CITY OF SAN ANTONIO

Re: Cardinal Meadows

MDP # 009-06

The City Staff Development Review Committee has reviewed Cardinal Meadows Master Development Plan M.D.P. # 009-06. Please find enclosed a signed copy for your files. Your plan was accepted however please note the following:

CARDINAL MEADOWS SUBDIVISION
 MASTER DEVELOPEMENT PLAN
 SITE PLAN
 CITY OF SAN ANTONIO
 BEXAR COUNTY
 REGD. PLAN

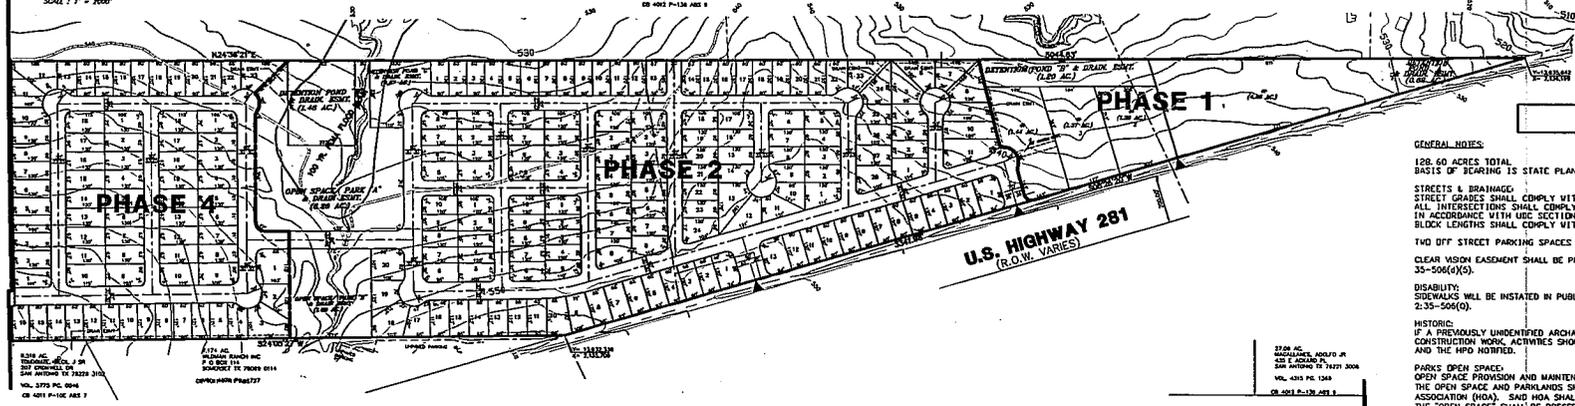
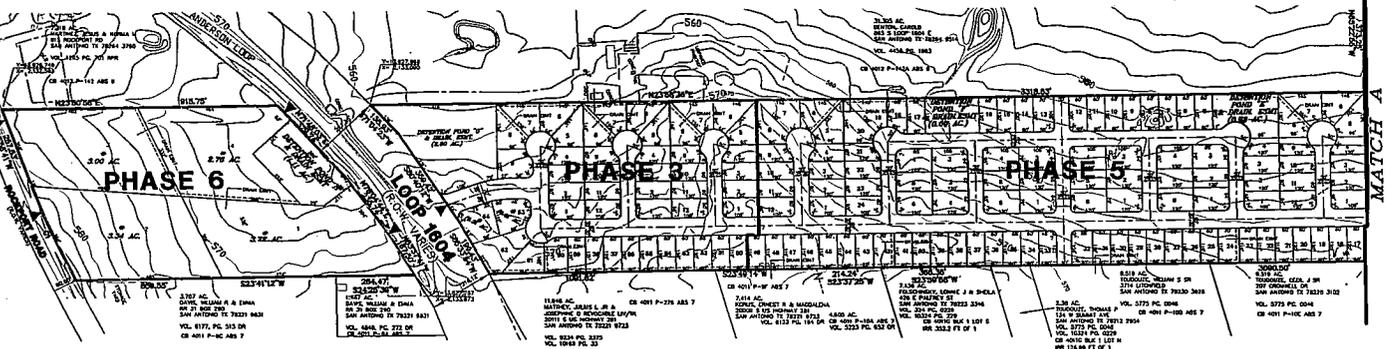
- In consideration of public safety and convenience, excessive grades by reason of topography should be avoided in street layouts and arrangements.
- Any access and R.O.W. issues along state facilities will need to be resolved with the **Texas Department of Transportation (TXDOT)**. For information about these requirements you can contact TXDOT at 615-5814.

- **Storm Water** state that the following conditions are required prior to future plat releases by this department:
 - Regarding the existing FEMA floodplain which overlays Detention Ponds "C" and "D" – Please **EITHER** provide a drainage easement that to include both the regulatory (100-year Ultimate Development) floodplain and the detention basin OR a FEMA Letter of Map Revision (LOMR) will be required as part of the Phase III development

- Please show complete drainage areas on Drainage Area Maps. Area A appears to have been "cut off" on the submitted Master Drainage Planning

- Please clearly label all calculations. (The Detention Basin ID was not indicated on the submitted Detention Storage Calculations.)
- Please provide detention basin hydraulic (inflow/outflow) analyses that consider each of the 5-, 25-, and 100-year storm events

- Please verify that submitted calculations are with each other, or explain discrepancies. (The Ultimate Development Q100 values in the submitted Storm flow Calculations.)

- Please note that a Floodplain Development Permit will be required for Phase 3 of this development.
- TIA & Streets indicate the following requirements and on-site improvements are necessary and shall be provided by the developer. On and before the completion of the Cardinal Meadows, at no cost to the City of San Antonio

- All roadways shall follow Table 506-7, Functional Classification System Description and shall comply with UDC 35-502(a)(9)
 - All access roadways shall provide clear sight distance on all existing and proposed roadways in order to provide adequate obstruction free reviewing distances for approaching traffic. All signage, landscaping, and improvements shall be selected and located so as to not block these clear sight distance areas.

- Construct an eastbound left turn lane and westbound right turn lanes on Loop 1604 at the proposed Collector Street into Phase-3 with storage lanes and bay tapers as it relates to the submitted TIA counts, UDC 35-502(a)(7), subsection C, and as per TxDOT requirements (70 Peak left turn and 106 peak right turn movements).

- All commercial driveways for this project shall comply with UDC-35-506, ® Access and Driveways.
 - Sidewalks along all interior and exterior roadways are to be installed in accordance with UDC 35-506(q)
